STAFF REPORT

CASE NUMBER: P.D. 18-26

1440 Getwell Road Planned Development

Expand the property limits of the existing convenience store onto the adjoining residential lot to the east to add additional parking space for the convenience store

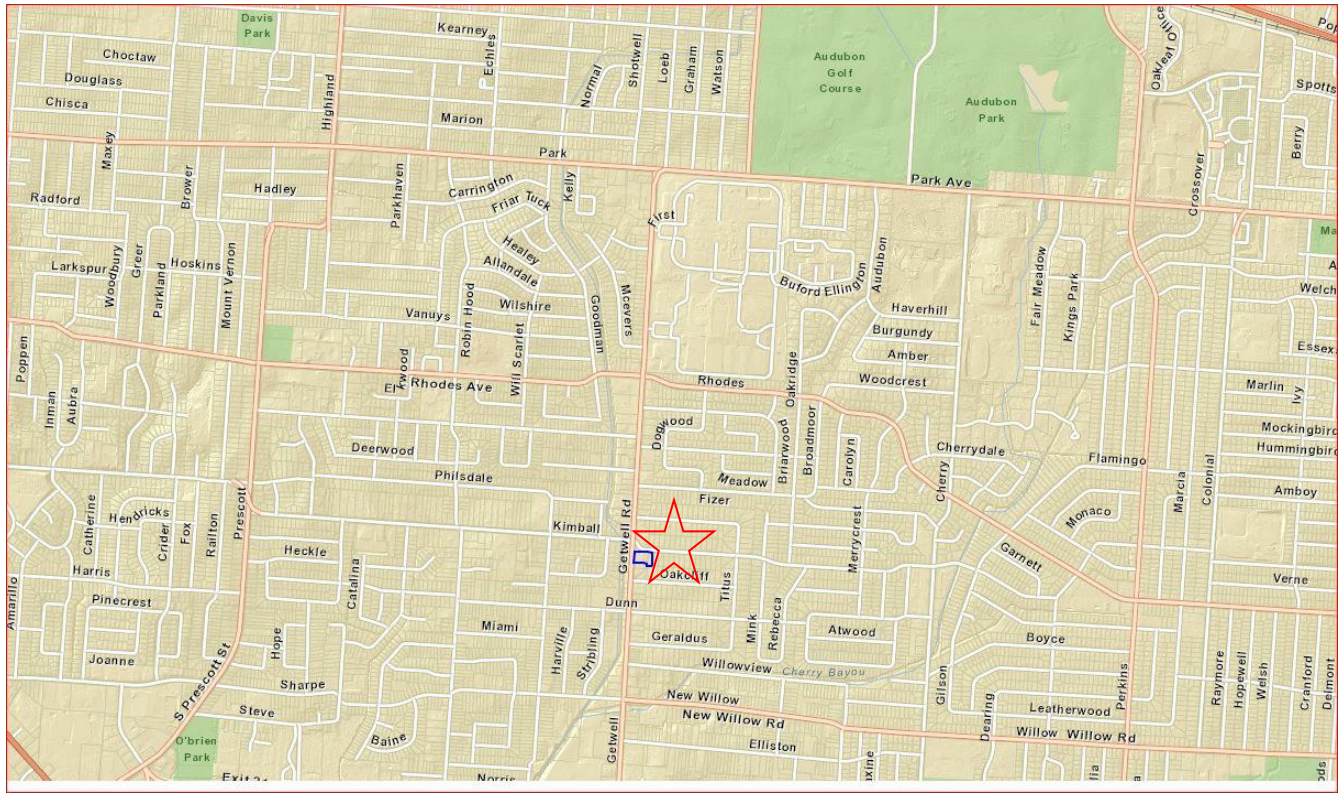
1. The request as illustrated by the site plan on page 9 of this report, falls short of meeting the purpose and intent of a planned development. In fact, the site plan is a good example of the development that would be permitted if both the commercial and residential portions of the site were zoned commercial.
2. In review of the site plan found on page 9 of the report, staff does offer some suggestions for changes or clarification.
3. However, even with those changes, staff cannot support what it sees as an unwarranted encroachment into a residential area.

The request as illustrated by the site plan on page 9 of this report, falls short of meeting the purpose and intent of a planned development. In fact, the site plan is a good example of the development that would be permitted if both the commercial and residential portions of the site were zoned commercial.

While the applicant might argue that this site plan represents a coherent and coordinated development, staff would argue that by extending the parking past the zoning line of demarcation between commercial and residential, you are in fact encouraging non-residential based trips into the residential area.

Staff does not support this request. If the reviewing bodies are inclined toward approval staff suggests the following changes to the site plan.

1. Along the east and south property lines, replace the proposed sight-proof wooden fence with a brick or similar masonry fence.
2. Along the Kimball Avenue frontage, continue the serpentine designed fence, but commit to the fencing being wrought iron.
3. Commit to some hours of operation for the parking area to no later than 7 P.M.
4. Provide a security gate to close off access to the gate. Gate will match the wrought iron fence.
5. Provide a lighting plan that demonstrates that any trespass of light beyond the east or south property lines shall not exceed 1 candle foot in intensity.
